HAYHURST
NEIGHBORHOOD
ASSOCIATION

One Page of
Concerns:

LU Case #LU 16-159330 LDS EN

Re: LU 16-159330-LDS EN

**Figure 3-21
Pendleton Creek Sub-Basin
Drainage Areas**

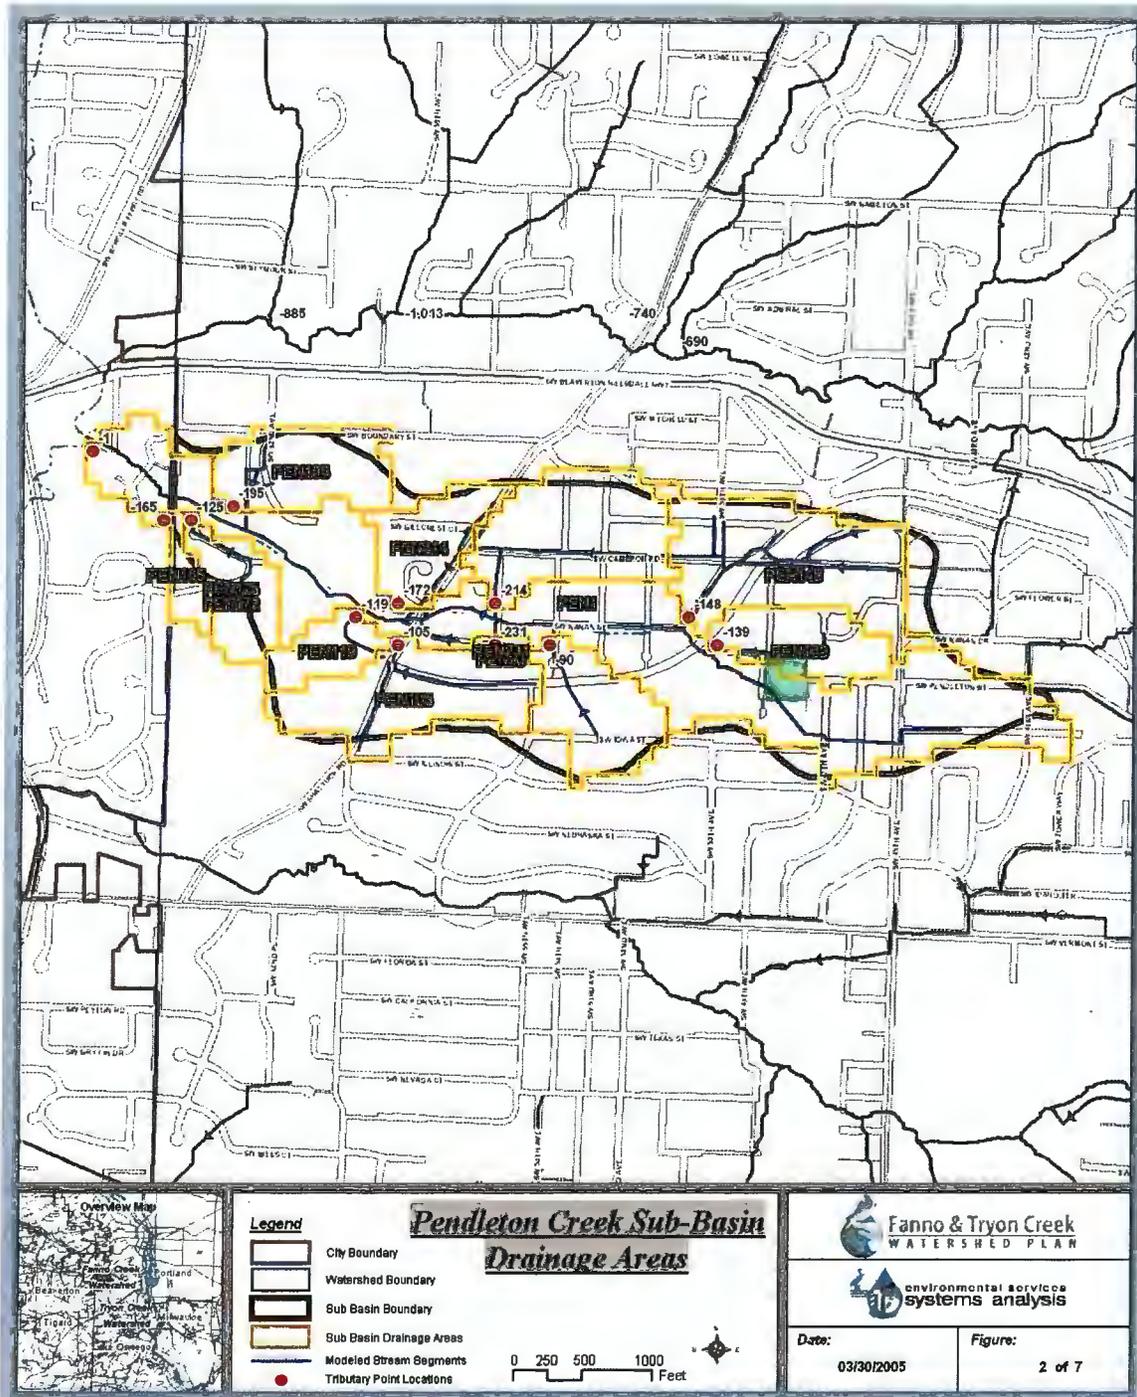
3.) Fanno Creek and Tributaries Conservation Plan. The Fanno Creek Plan acknowledges that seasonally saturated aquifers commonly occur in the subject watershed. Newly identified springs clearly drain into the delineated wetland.

(EXHIBIT#3 Pendleton Creek Sub-Basic Drainage Areas)

**MAP OF
TRIBUTARIES
TO FANNO
CREEK**

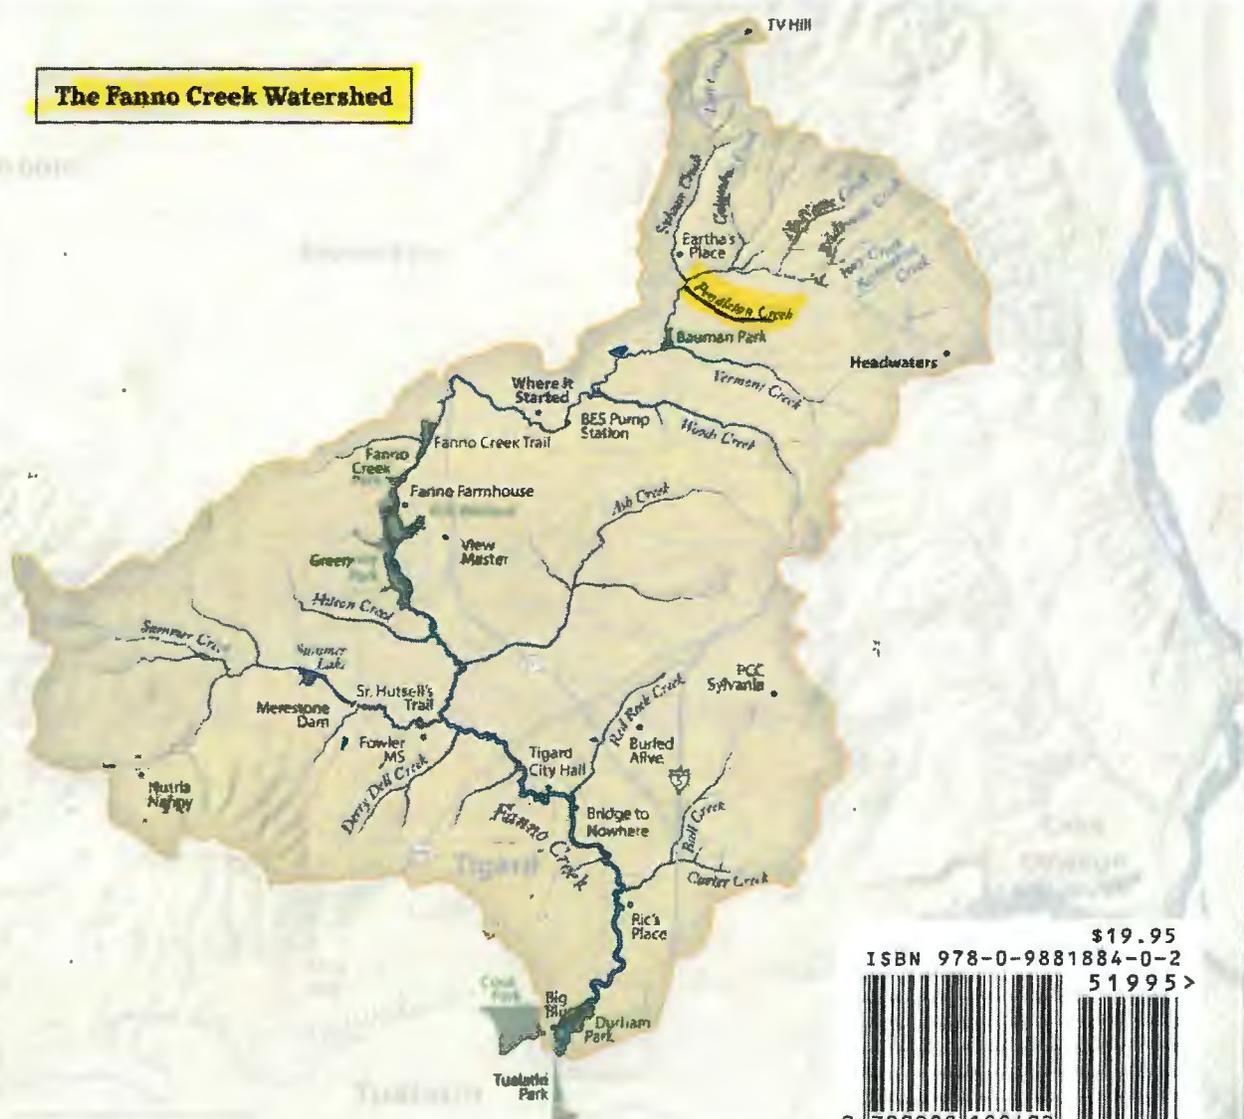
(EXHIBIT#4 MAP of tributaries of Fanno Creek)

PPS School Finder 2017-18

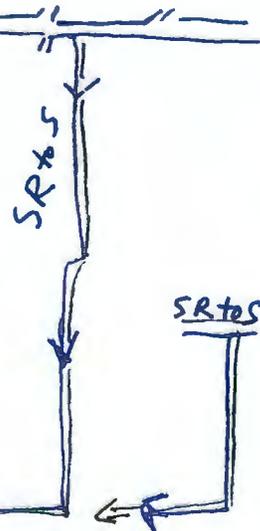
4.) Pedestrian and bicycle safety: Safe Routes to School. SW 48th is heavily used by parents, school children and residents of SW Portland. It is the only Safe Route to School north of Hayhurst Elementary School.

only existing through SR to School from NORTH
